BEFORE THE STATE OF CALIFORNIA
STATE WATER RESOURCES CONTROL BOARD

In the Matter of
Water Quality Certification for the
DeSabla – Centerville Hydroelectric Project

FERC Project No. 803

**COMMENTS OF CONSERVATION GROUPS ON PACIFIC GAS & ELECTRIC
COMPANY’S 2011 ASSESSMENT OF FISH MIGRATION BARRIERS ON THE
WEST BRANCH FEATHER RIVER, SPECIFICALLY IN TERMS OF THEIR
RELEVANCE TO PG&E’S MAY 8, 2015 PETITION FOR RECONSIDERATION OF
THE WATER QUALITY CERTIFICATION FOR THE DESABLA – CENTERVILLE
HYDROELECTRIC PROJECT**

Figure 1: Hendricks Diversion Dam during high spring flow⁶

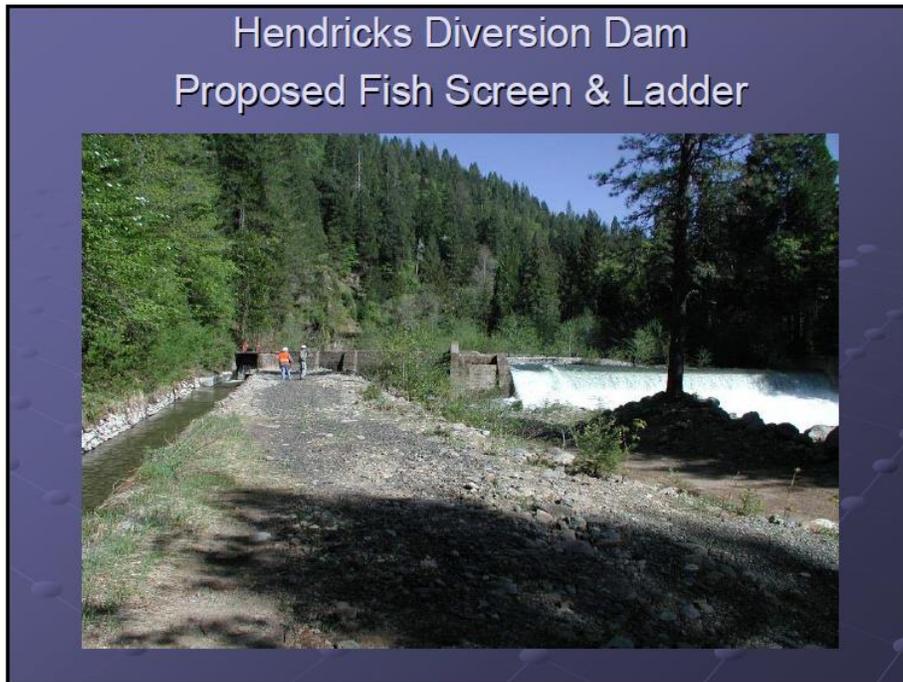
The Hendricks Diversion Dam is a 15 foot tall concrete structure across the West Branch Feather River, with a notched spillway 98 feet wide. The diversion headworks are located on the dam near river right. At high water, water spills over the diversion dam. (See Figure 1, right side of the photo). At lower flows typical of summer operation, the West Branch ceases spilling over the dam, and the entire flow of the West Branch is diverted into the Hendricks Canal at the headworks (Figure 2). Under non-spill conditions, some of the water that was previously diverted into the Canal is released as the bypass flow from a side-gate several hundred feet down the Canal from the headworks (Figure 3 top view and Figure 4 bottom and side view). This operation completely separates the West Branch Feather River upstream and downstream of Hendricks Diversion Dam.

Figure 2: Hendricks Canal Head Gate⁷

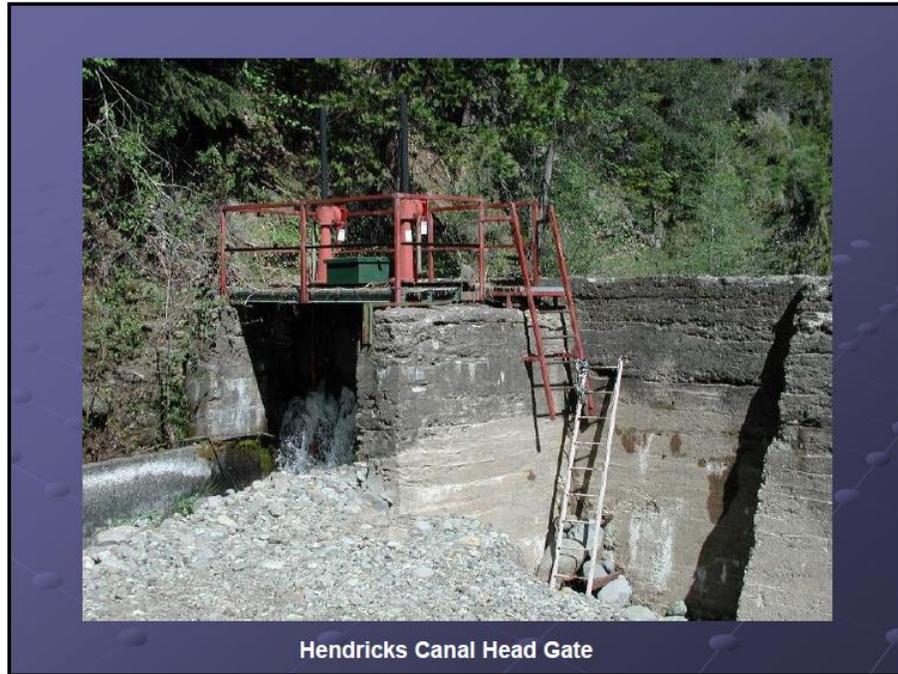
Under all circumstances, the combined works constitute a complete barrier to upstream fish passage. In addition, once fish enter the Hendricks Canal, the velocity of the water at the headworks as it enters the canal is too great to allow fish to escape from the Canal back into the river. Finally, fish that are discharged into the West Branch from the side gate in the instream flow release are unable to re-enter the Canal.

Figure 5: Plan view of Hendricks fish screen and ladder⁹

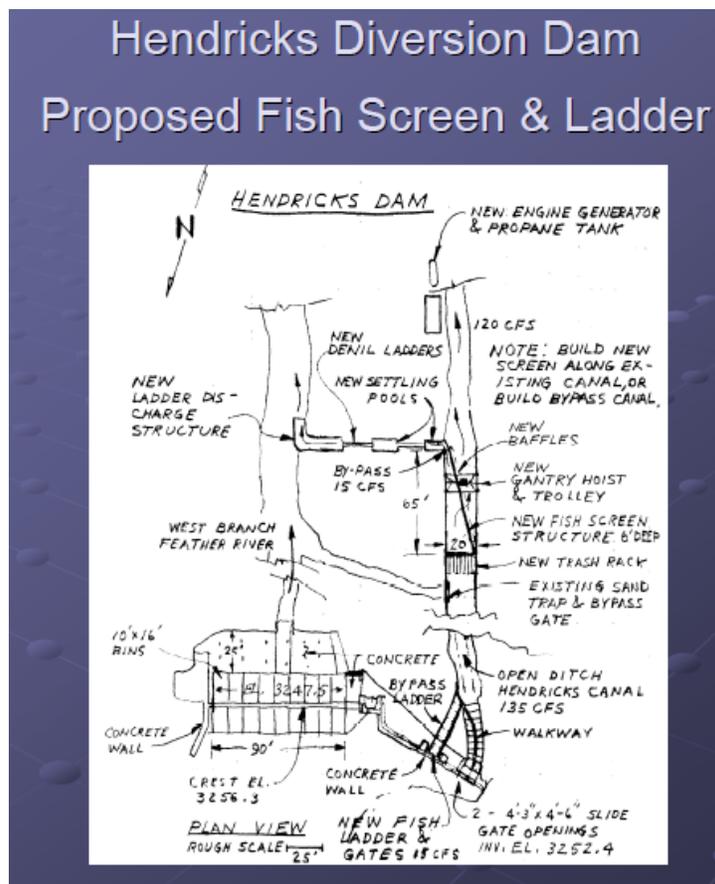
In two separate appendices to the Final License Application for the DeSabra – Centerville Project, PG&E provided drawings of a fish screen for the intake of the Hendricks Canal. In each case, the drawings show that the screen will be configured such that fish are not prevented from entering the canal. Rather, those fish that do enter the canal will be screened into the bypass flow and then discharged into the West Branch Feather River downstream of Hendricks Dam. See Figures 5, 6 and 7 below.

To our knowledge, PG&E has not modified its proposed designs for a fish screen and fish ladder at Hendricks Diversion and Hendricks Canal. PG&E has not provided additional drawings in either the FERC docket for the relicensing or to the State Board. As explained during relicensing, the absence at relatively lower flows of water flowing past the intake makes a more conventional screen design, which would keep fish out of the Hendricks Canal altogether, ineffective.

A consequence of this fish screen design is that in the future, there will be hundreds if not thousands of fish that are discharged each year into the West Branch Feather River. In the past, these fish would simply have been entrained further down into the Hendricks Canal.
